SUBJECT: Transmittal of Revised Responses to AP1000 DSER Open Items

AP1000 Design Certification Review
Draft Safety Evaluation Report Open Item Non-Proprietary Responses

DSER Open Item Number: 3.8.2.1-1 Revision 2

DSER Open Item Number: 19.1.10.1-5 (Response Revision 2)

Figure A5.3-15

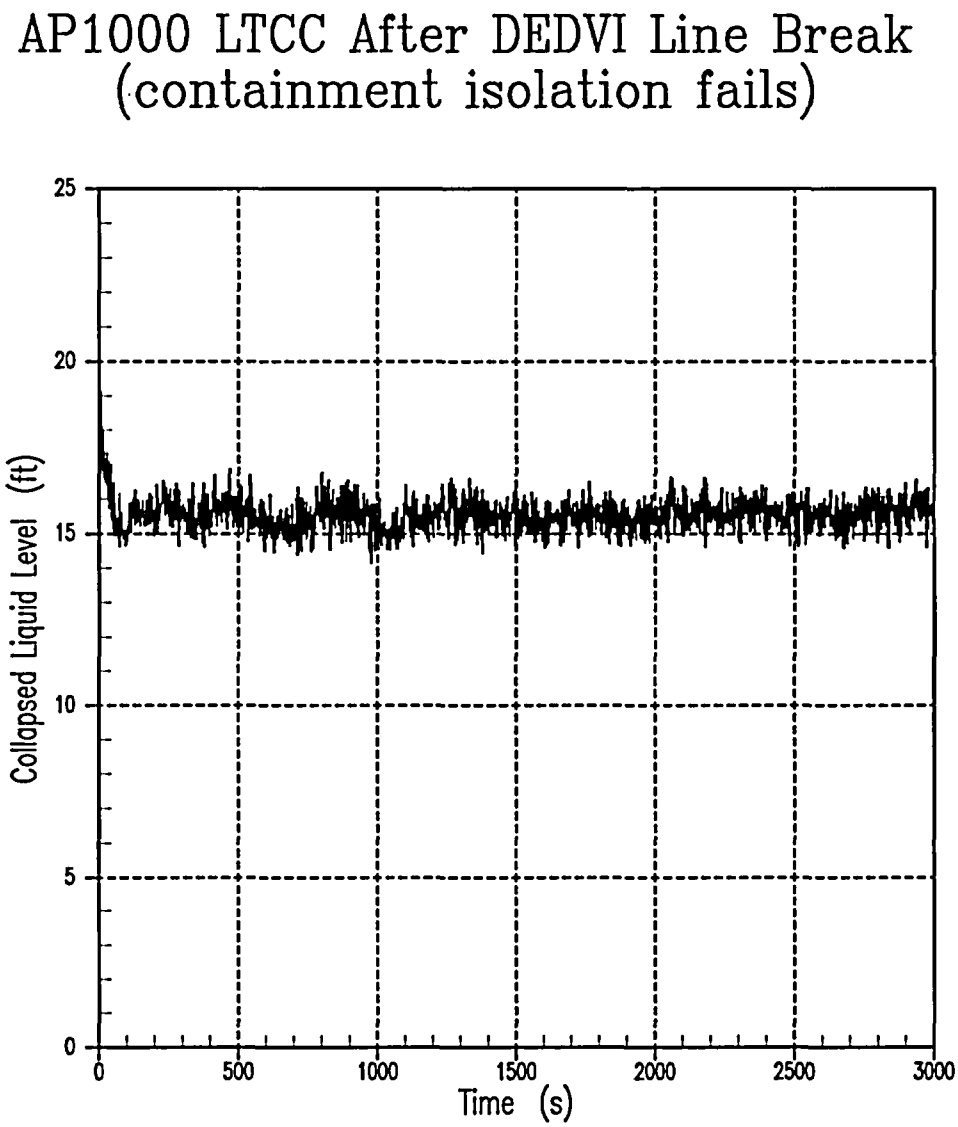
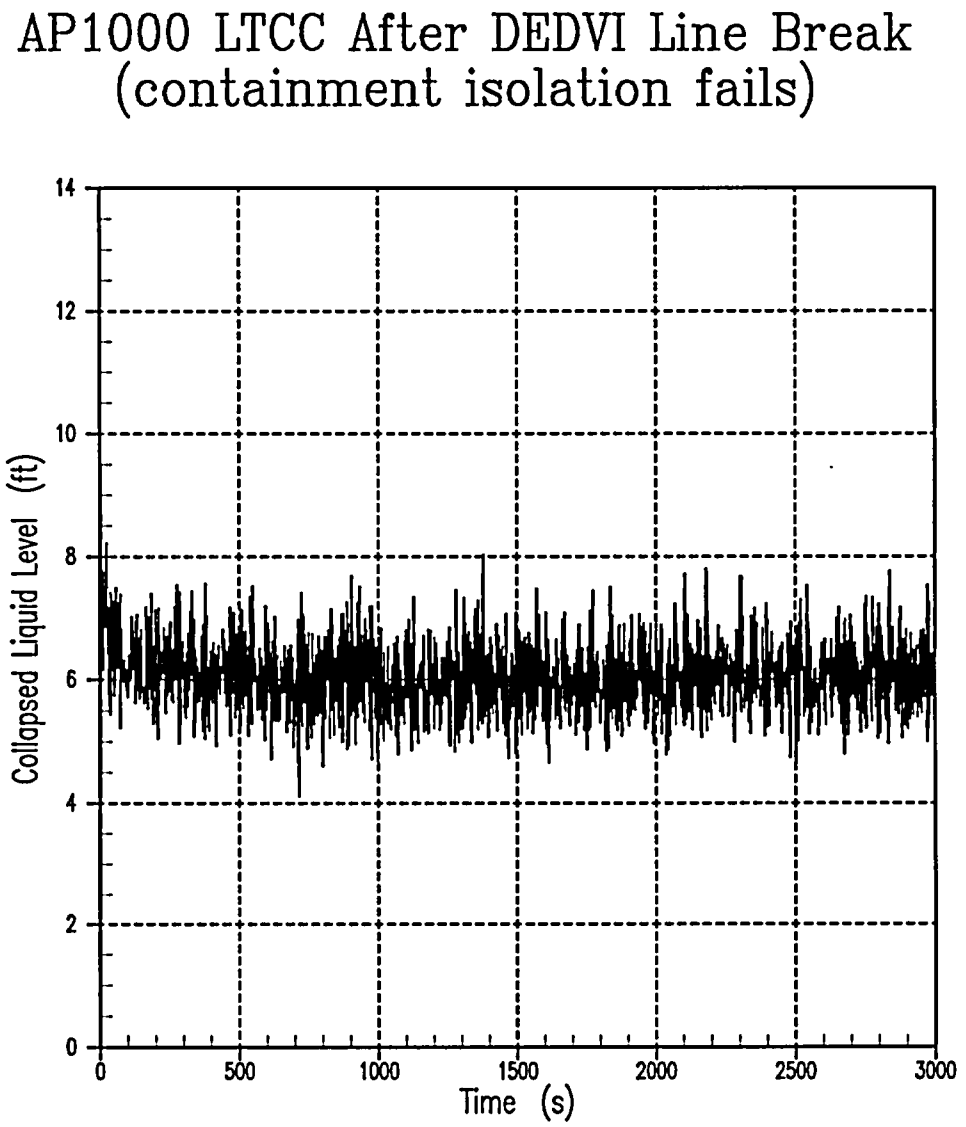
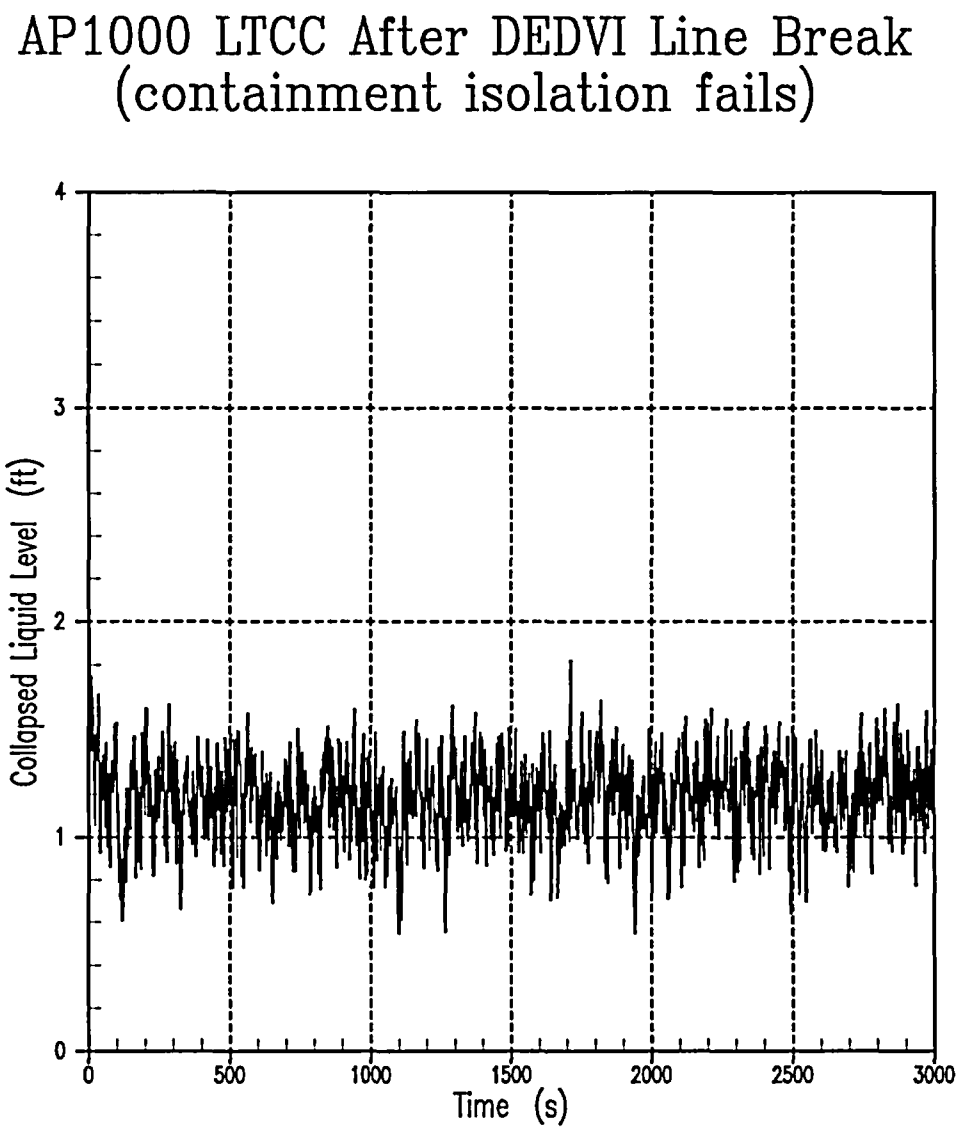
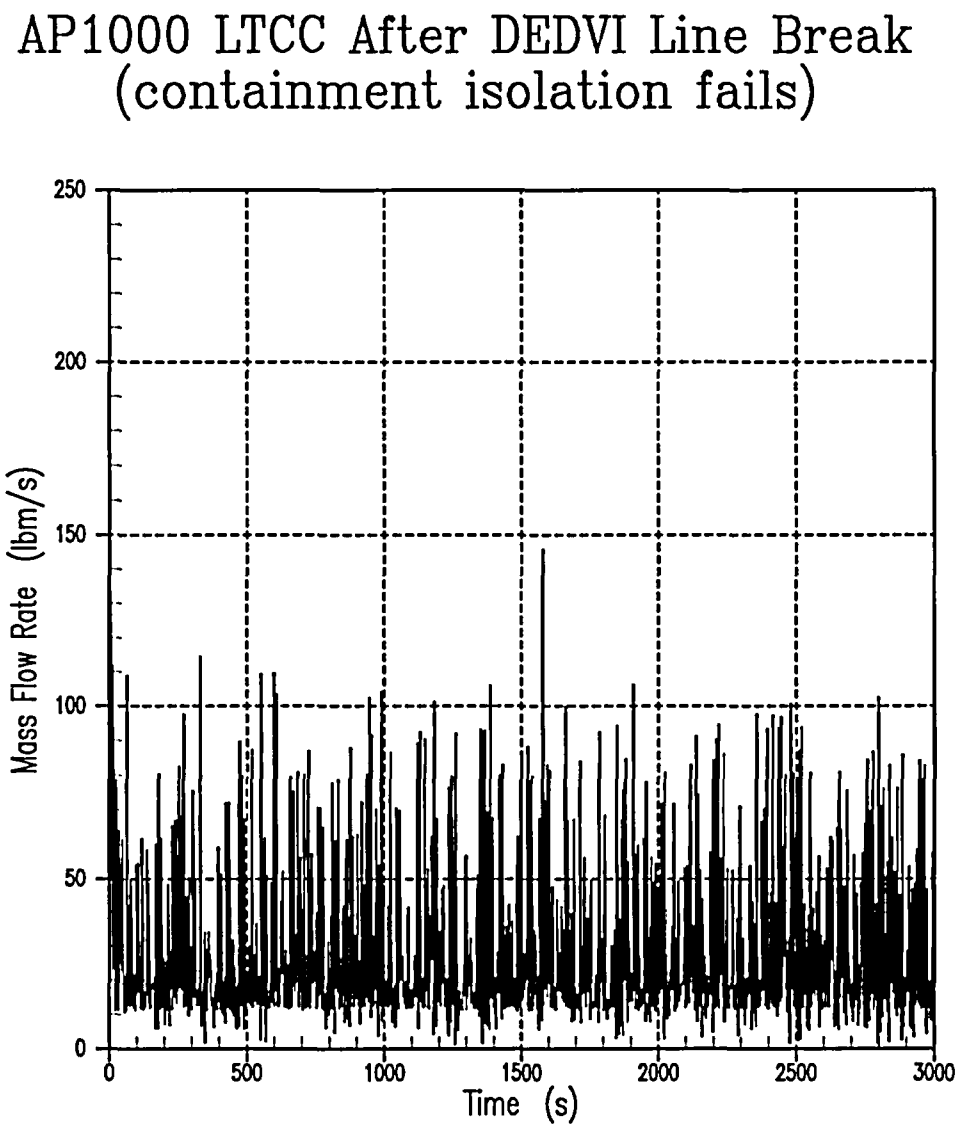
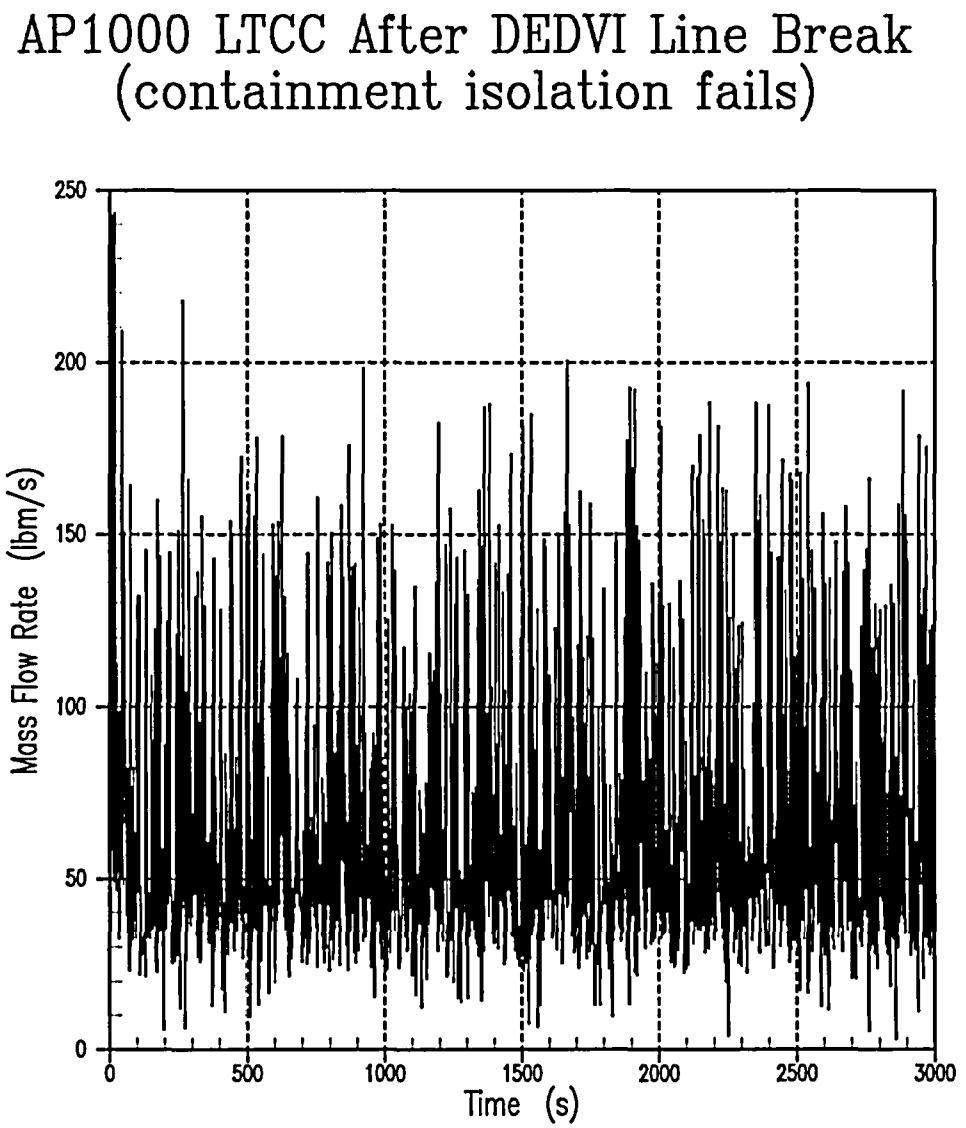
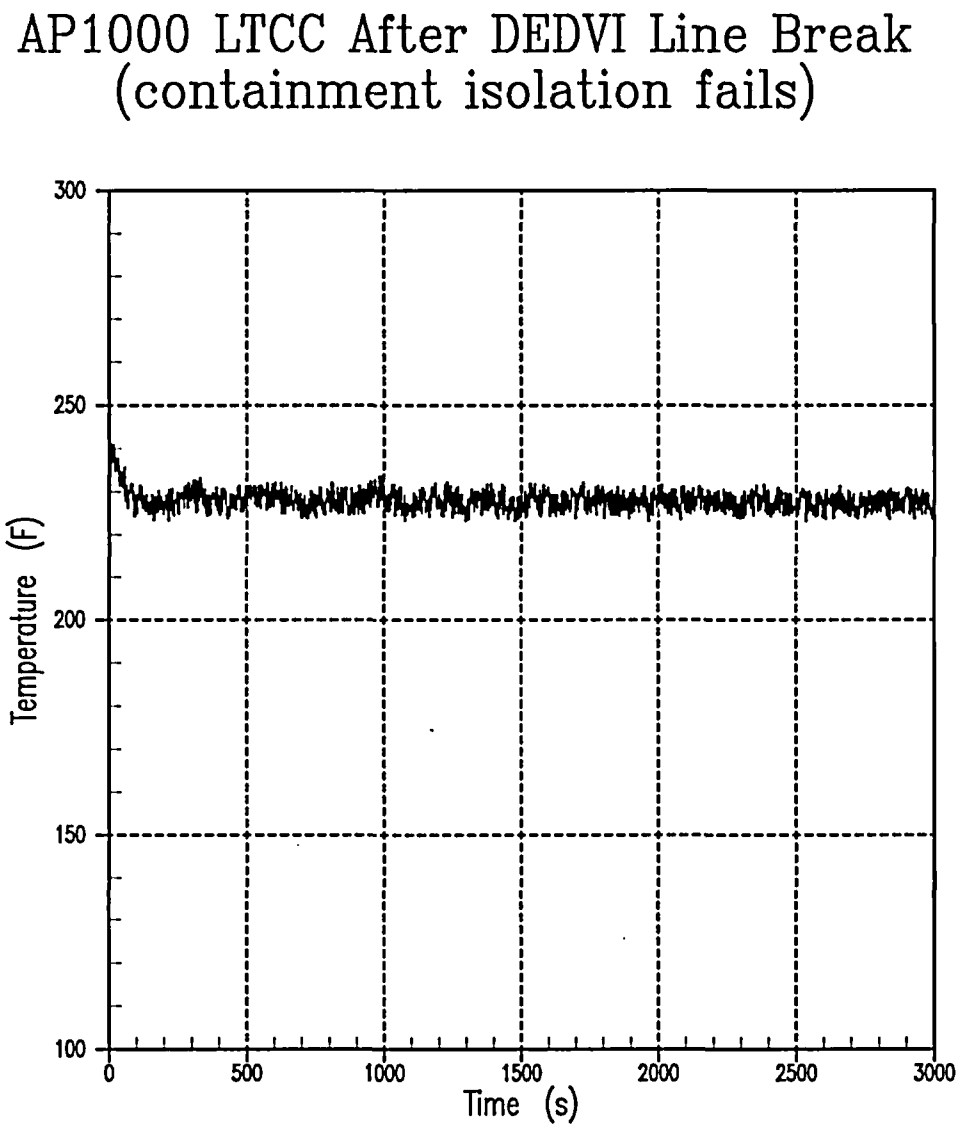
(f) Additional justification should be provided that sequences which assume failure of one of the four ADS stage #4 valves and also assume failure of containment isolation, will end in successful core cooling (RAIs 720.012, 720.009 and 720.017):

This issue is unresolved. In the revised response to RAI 720.09, Westinghouse presented the results of an analysis using WCOBRA/TRAC with inputs determined from a MAAP4 analysis. The staff has the same issue with this analysis as is stated under Item a. In the revised response to RAI 720.17, Westinghouse argued that this case is not risk significant and therefore it is not necessary to perform a T&H uncertainty analysis. This argument is not valid since OK6 (See Figure 2-4 of RAI 720.012), OK2 and OK4 sequences (on Figure 2-5 of RAI 720.012) fall in this category. Are these OK sequences considered to be low risk?

(f) The long term cooling success criteria analysis in the revised response to RAI 720.09 (3 of 4 ADS4, containment isolation failure) has now been performed using the revised WCOBRA/TRAC model and using input conditions from WGOTHIC. The revised analysis replaces the previous one as shown below in the revision to PRA Appendix A. This confirms the success criteria for this case. With respect to the statement we made in RAI 720.017 rev 1 about a T&H uncertainty case with 3 ADS-4 valves and failure of containment isolation, we have the following response. Such a sequence is not risk important with the current expanded event trees. The question regarding sequences that we identified as OK sequences with 3 ADS-4 valves and CI failure is a new / different question. These sequences are less severe than the success criteria case in that they have some ADS 2/3 valves opening and have 1 CMT (in addition to 1 Accumulator). The addition of the CMT will compensate for the water lost out of the containment through a failed CI. In addition, these OK sequences have probabilities of ~ E-10 / yr, or less. The highest UC sequence with 3 ADS-4 and failed CI is UC8/sad27, see PRA Appendix A Table A5.1-2. This sequence has a CDF probability of 2 E-10 and is not risk important.

The availability of all ADS Stage 4 valves provides enough venting capacity to assure adequate depressurization and successful performance of the passive safety systems (Figures A5.3-23 and A5.3-24). The fuel remains covered throughout the transient, and adequate core cooling is provided to remove the decay heat. The hot rod cladding temperature **at the top of the core** is about 20°F above saturation (Figure A5.3-26) ~~and steadily decreasing~~.

Figure 19.1.10.1-5 R2-1: Cold Water Droplet Size Sensitivity

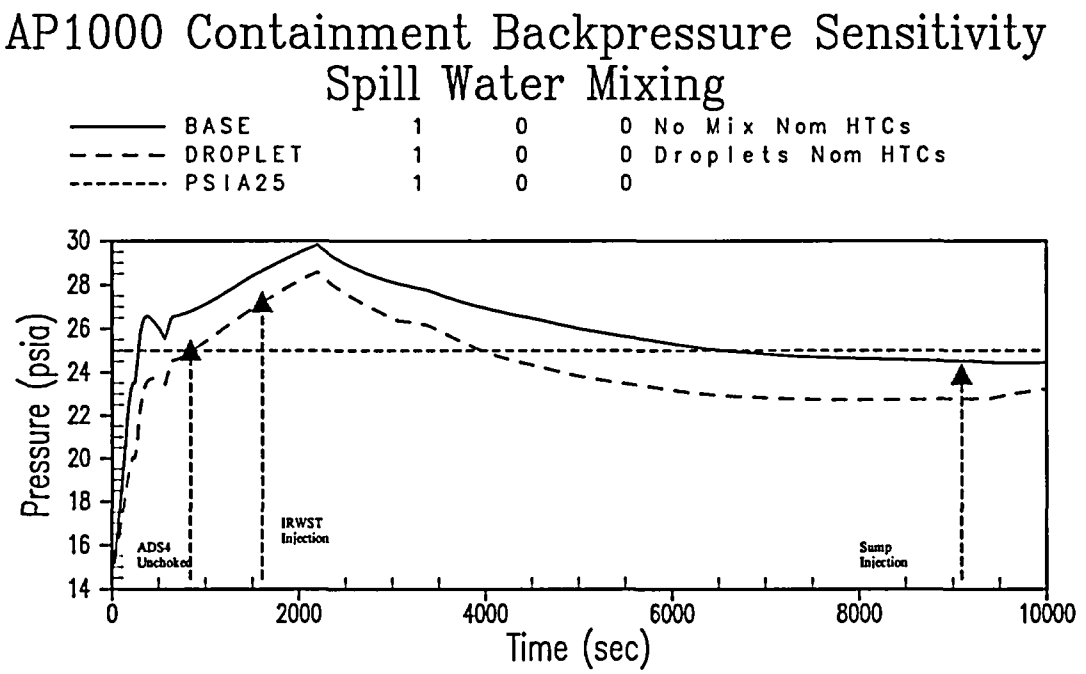
Westinghouse should quantify the effect of lower containment backpressure as indicated in the response to OI 15.2.7-1 Item 7 on long term cooling performance.

In response to DSER Open Item 15.2.7-1 Item 7, a bounding calculation was performed with WGOTHIC to determine a conservative lower bound for the containment backpressure for the DEDVI case. For this analysis, it was assumed that the cold water spilled from the loop side of the DVI would be introduced into the compartment as 100-micron droplets. This assumption assures maximum condensation of steam in the compartment, and the containment pressure for this case was approximately 2 psi lower than the case where the cold water is spilled directly to the floor of the compartment as is shown in Figure 19.1.10.1-5 R2-1. For the NOTRUMP DEDVI case, it was determined that from the time that flow from the ADS-4 valves becomes unchoked until stable IRWST injection becomes established, the containment pressure is always above the assumed backpressure boundary condition of 25 psia. These conclusions formed the response to OI 15.2.7-1 Item 7.

An additional sensitivity study was performed with WCOBRA/TRAC to determine the effect of using this bounding containment backpressure for the AP1000 long-term cooling analysis. The DCD limiting case of a postulated DEDVI break in the PXS "B" Room was reanalyzed using the pressure curve shown in Figure 19.1.10.1-5 R2-1 from the time of sump injection onward. Figure 19.1.10.1-5 R2-2 compares the core collapsed liquid level predictions of the DCD analysis (dashed line) and the sensitivity case (solid line); the time axis of the WCOBRA/TRAC runs has a 2500 second time offset from the WGOTHIC case. In Figure 19.1.10.1-5 R2-2, the sensitivity case exhibits no adverse impact on core cooling relative to the DCD analysis; no cladding temperature excursion is predicted for either analysis. The long term cooling analyses for the DCD and PRA are not sensitive to the slightly lower backpressure indicated by the WGOTHIC bounding analysis.

Figure 19A.2-8-1
Actual Footprint Modeling

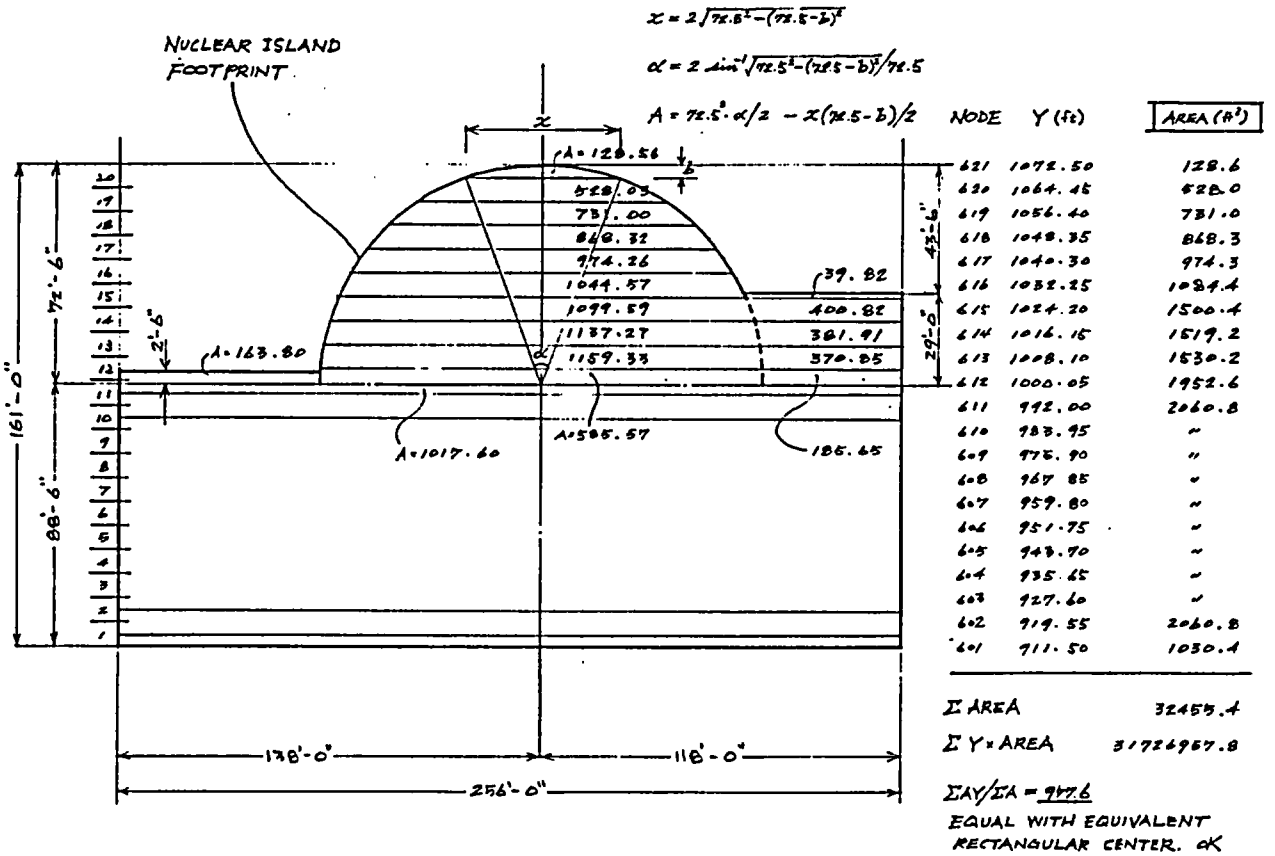
Westinghouse has not adequately justified that the effect of lift off of the nuclear island basemat is not significant in the seismic margin evaluation. The results that are presented in the Revision 1 response may cause the HCLPF values to fall below the review level earthquake of 0.5g. Further, the CIS lift off with the nuclear island basemat uplift may make the seismic response worse. Westinghouse has not presented results from a combined model with liftoff from the CIS and nuclear island basemat to demonstrate that the results are not higher than those presented.

A new model was developed that models more accurately the actual footprint of the basemat. The actual footprint configuration is modeled as shown in Figure 19A.2-8-1. The overall width is 161' whereas the equivalent rectangle only had a width of 140'. Both have the same overturning resistance in linear analyses where soil springs take tension. Both models have the same eccentricity between the center of mass of the nuclear island and the centroid of the basemat.
